| TYPE | YEAR | PROJECT NO. | SHEET NO. |
|---|---|---|---|
| CONST. | 2017 | HSIP-106(33) | 28 |

S.R. 106 WILLIAMSON CO.

BEGIN STA. 107+50.00
END STA. 108+50.00

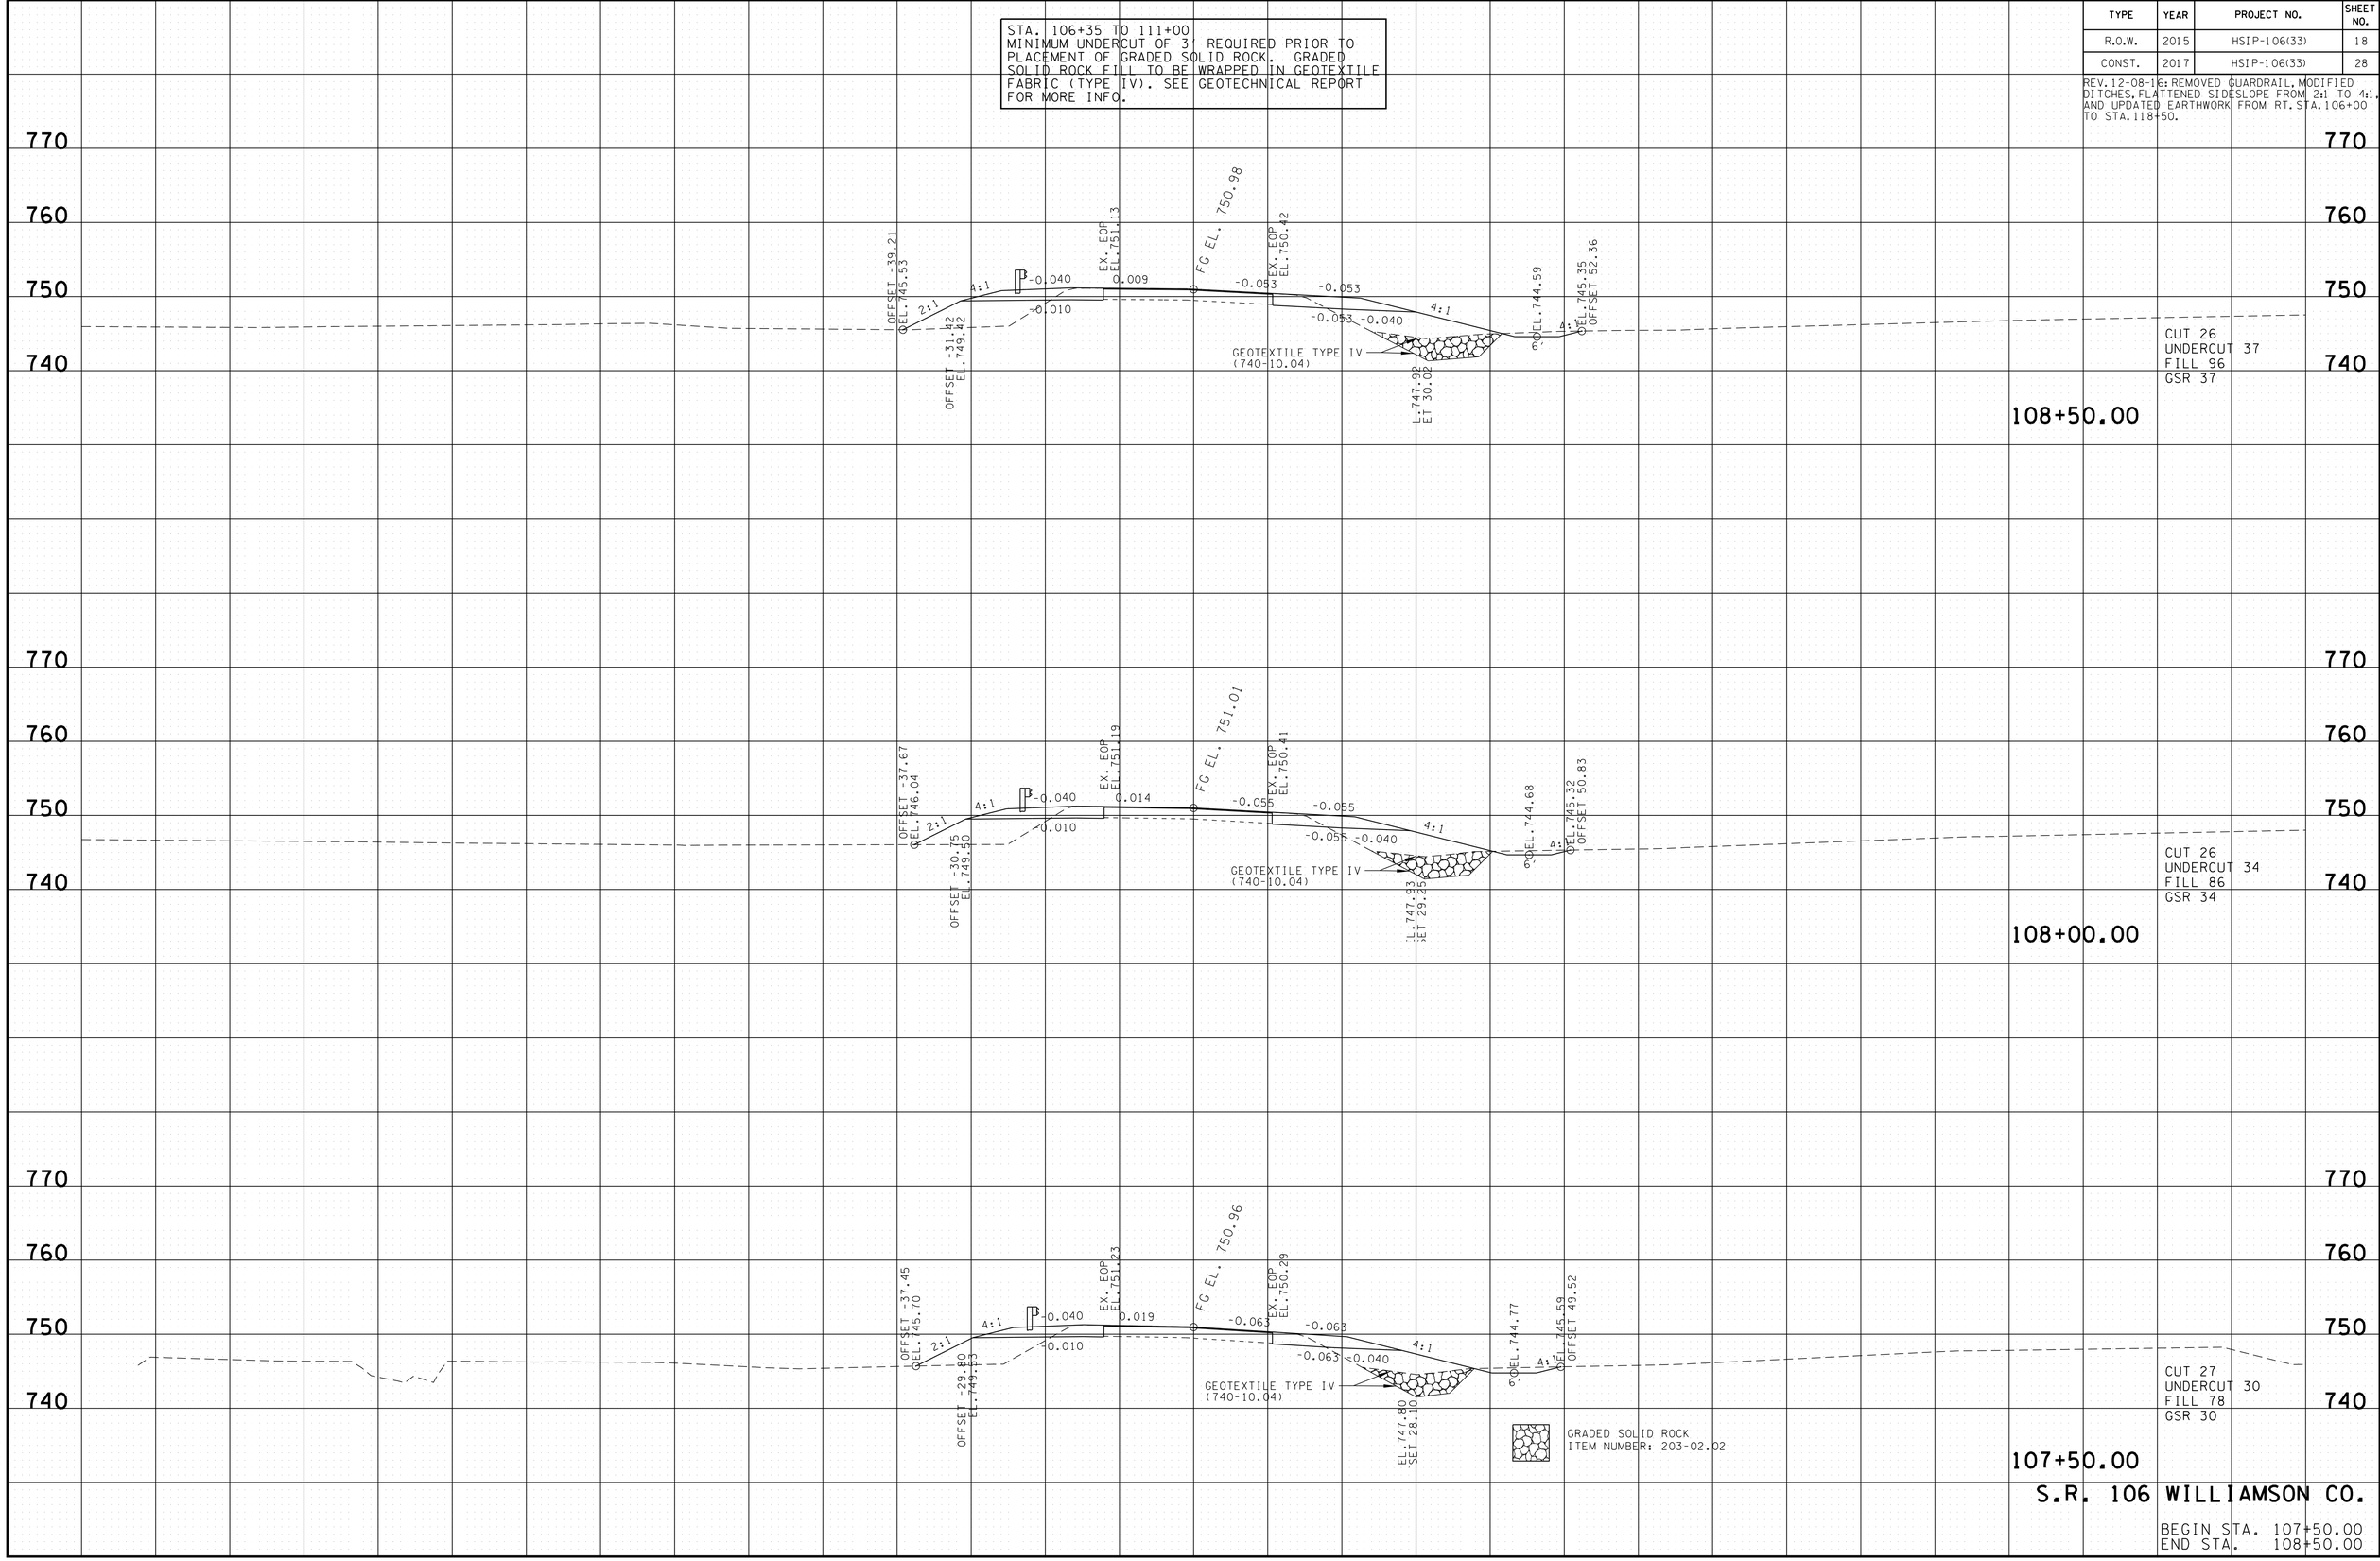
REV. 12-08-16: REMOVED GUARDRAIL, MODIFIED DITCHES, FLATTENED SIDESLOPE FROM 2:1 TO 4:1, AND UPDATED EARTHWORK FROM RT. STA. 106+00 TO STA. 118+50.

STA. 106+35 TO 111+00
MINIMUM UNDERCUT OF 3' REQUIRED PRIOR TO PLACEMENT OF GRADED SOLID ROCK. GRADED SOLID ROCK FILL TO BE WRAPPED IN GEOTEXTILE FABRIC (TYPE IV). SEE GEOTECHNICAL REPORT FOR MORE INFO.
